We thank the reviewers for their comments. Below are our responses in blue.

## **Response to Reviewer 2**

This study presents airborne measurements collected by the VIPR instrument during two recent field studies, IMPACTS and SOA2RSE. The authors describe the retrieval to derive water vapor profiles and partial column estimates by using the Differential Absorption Radar technique, accounting for differential hydrometeor scattering by including a third frequency. Water Vapor estimates are compared to dropsondes and ERA5 fields. The complementing nature of DAR and DIAL is illustrated in examples from the SOA2RSE flights.

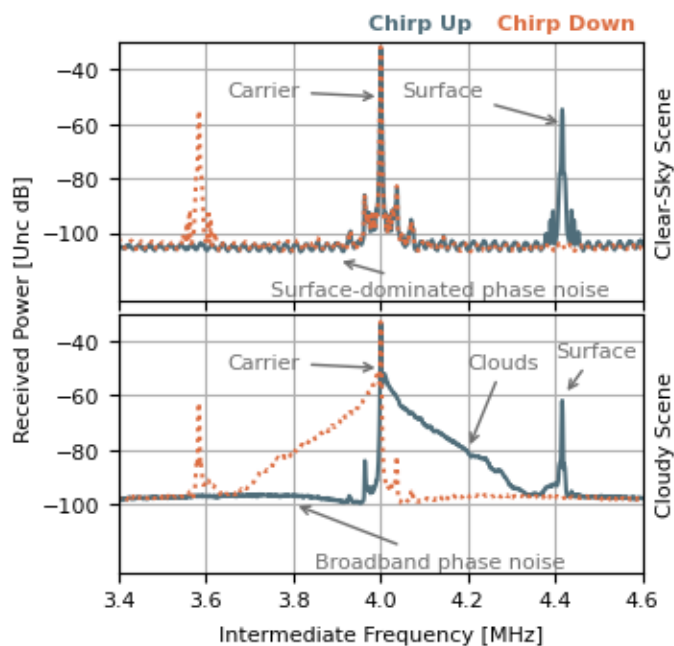
- drop Fig 2: readily available in literature (eg Roy et al 2018, Fig 3). While we agree that this figure is available elsewhere, we believe is important to have it so the reader understand the chirp up/chirp down difference. Many readers of this paper will likely not be experts in FM radar techniques which are essential to understand Fig 3.

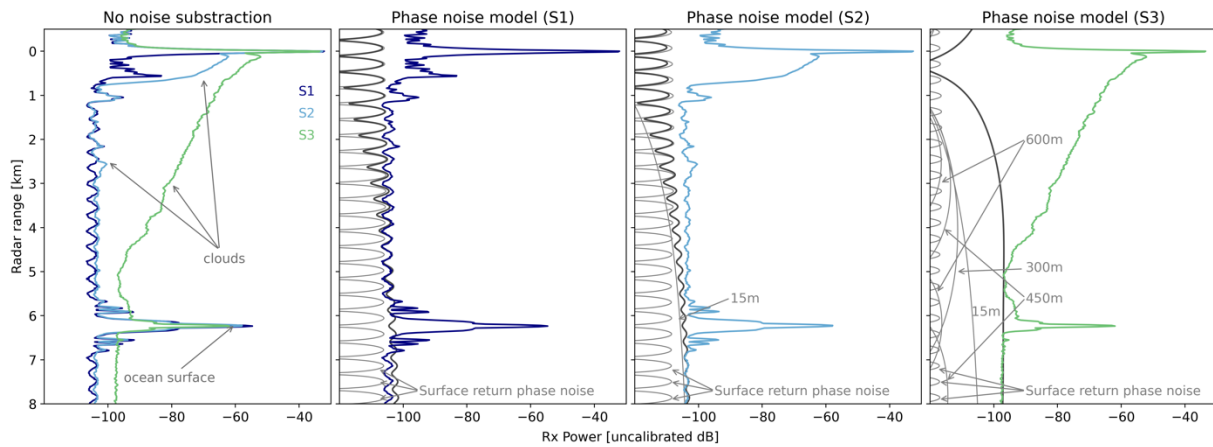
- reshuffle Figure 4 and 5, e.g. by adding the bottom panel of Fig 5 below Fig 4; and combining most right panel Fig 4 with three panels Fig 5.

The figures were reshuffled as requested:

With the caption now reading: Uncalibrated VIPR 167.12 GHz reflectivities measured during the first ~40 minutes of the January 14 flight with no noise subtraction (top), with noise subtraction (middle), and with noise subtraction and confidence flag (bottom). The noise subtraction is indicated by the pink/green bar (for phase noise and thermal noise, respectively).

With the caption now reading: (left) Radar reflectivities at the three slices indicated in Figure 4, depicting scenarios with clear sky (S1, navy line, featuring a bright reflection around 6.5 km), a partly cloudy scene (S2, light blue), and a cloudy scene (S3, green). (right) Phase noise model simulations for each of these slices. The integrated phase noise model is depicted in dark gray, while phase noise model examples at different ranges are shown in light gray.

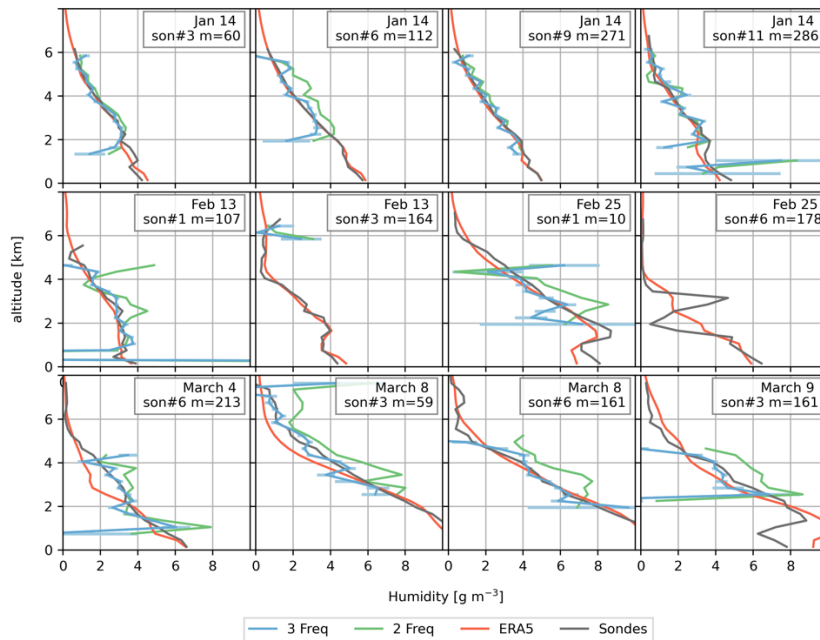
- Figs 6-9: adding the height of the melting layer would be an important additional piece of information.

We added the melting layer to the figures as requested (see updated manuscript). We also added the melting layer to figure 14 (the DAR/DIAL curtains).

We also added the following text to the caption: Magenta dashed lines depict the melting layer derived by interpolating the ERA5 reanalysis fields to the VIPR measurement times and locations.

Figure 15: Normalized histogram of the humidity retrievals during the SOA<sup>2</sup>SE March 8th and March 9th flights using either DAR/VIPR or DIAL/HALO. The numbers in brackets represent the number of samples per instrument.

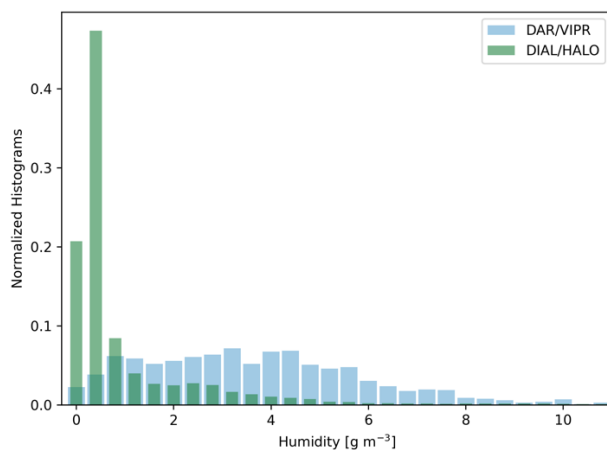
- Section 6 is very short and vague compared to Sec 4 and 5 while it is in my opinion one of the most novel findings of the paper. The authors should thoroughly quantify the synergistic benefits of the two instruments. The following questions could guide the analyses: How well do clear-sky pCWV agree between the two instruments? What happens at the edges from clear-sky to cloudy, when DIAL and DAR water vapor profiles follow one another temporally? How well do water vapor observations agree above cloud top (DIAL profile vs DAR pCWV)? I would suggest to add a Figure similar to Fig 13 to analyse the clear-sky pCWV.

A thorough quantification of the synergistic benefits of DIAR and DAR are outside the scope of this manuscript. That said, we added the following figure to further highlight the synergy of the two techniques.

To underscore the synergy of these techniques, Figure 15 displays the normalized histograms of the water vapor values retrieved by either DIAL/HALO or DAR/VIPR. As shown, DIAL/HALO displays a skewed right distribution with mode at  $0.4 \text{ g m}^{-3}$  (attributed to a majority of clear sky measurements), while DAR/VIPR exhibits a multimodal broad distribution with modes at 0.8 and  $4.4 \text{ g m}^{-3}$ . This synergy could ...

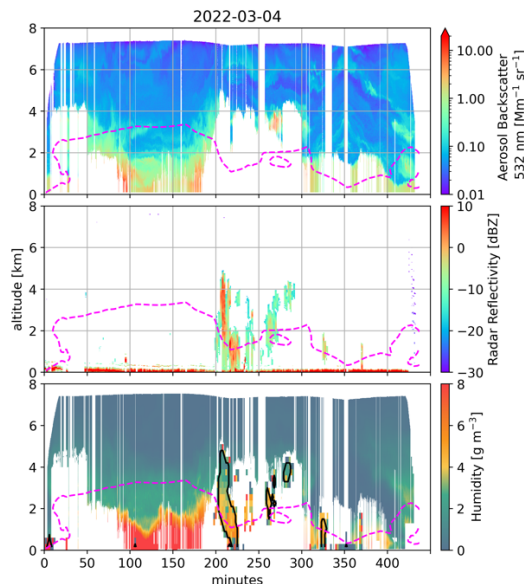
The authors should also comment on the performance of the synergy for the 03-04 and 03-07 flights. We added the figure below as an appendix figure.

In the manuscript we added: Similarly, Figure A1 displays the March 4th flight, note that there were no cloudy measurements on the March 7<sup>th</sup> flight.
